Notice of Allowability

10/779,831

SWIFT, EDGAR LEON

EXAMINER'S AMENDMENT

Fig. 4

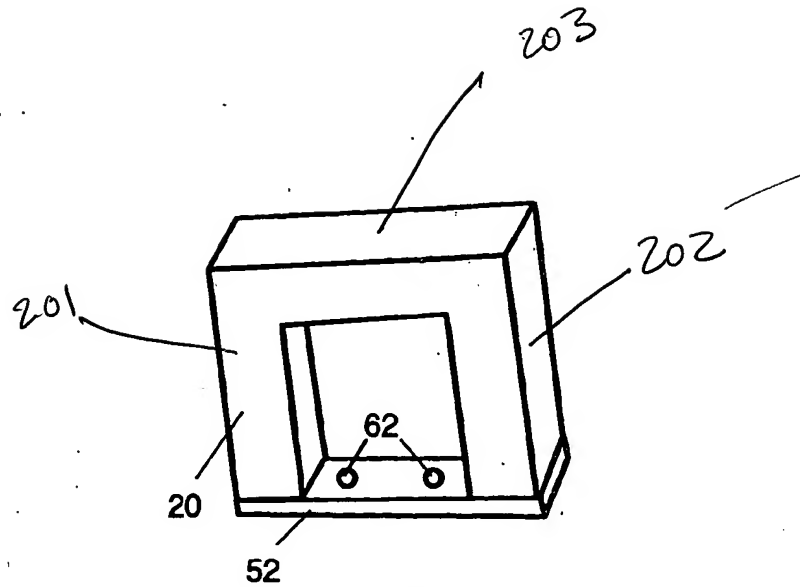
2. The following changes to the drawings have been approved by the examiner and agreed upon by applicant: the following element numbers have been added to figure 4 "201" and "202" to represent the upright portions and "203" to represent the handgrip

portion. See attached revised figure 4. In order to avoid abandonment of the application, applicant must make these above agreed upon drawing changes.
